SUNDRY NOTICES AND REPORTS ON WELLS
Do not use this form for proposals to drill or to re-enter an abandoned well. Use form 3160-3 (APD) for such proposals.

ConocoPhillips proposes to plug and abandon this well as per the attached procedure. Also attached is a proposed and current wellbore schematic.

PLUG AND ABANDONMENT PROCEDURE

Jicarilla 28 #7

Proposed P&A

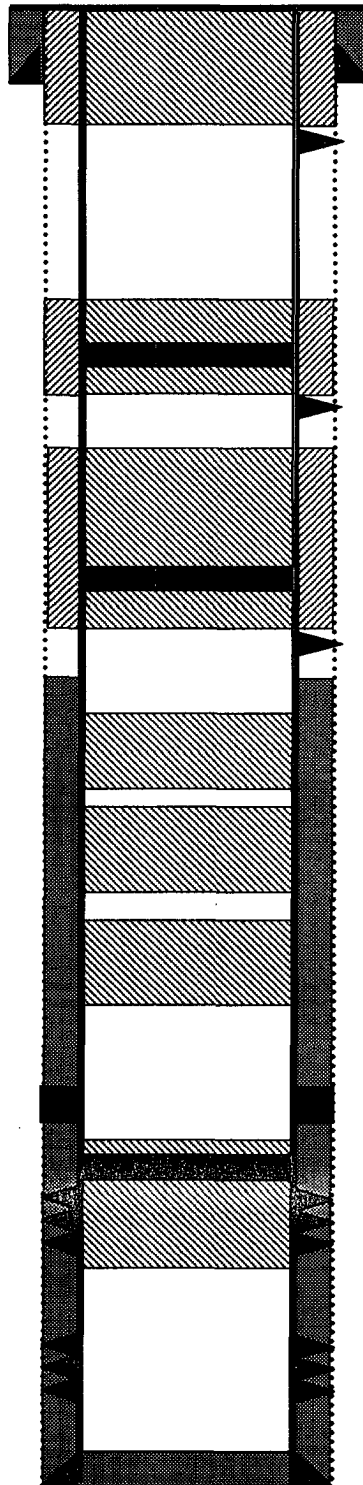
$285/7.299(1.32) = 30$ sxs
 $50/5.7719(1.32) = 7$ sxs
 $235/5.192(1.32) = 34$ sxs
71 sxs

$1505 - 1405 = 100$

Perforate @ 1295' $200/5.7719(1.32) = 26$ sxs

3164

$3164 - 2690 + 50/7.299(1.32) = 54$ sxs
Perforate @ 3065' $(3164 - 2690)/5.7719(1.32) = 124$ sxs

$16(7.299)1.32 = 154$

6207

$6536 - 6207/7.299(1.32) = 39$ sxs
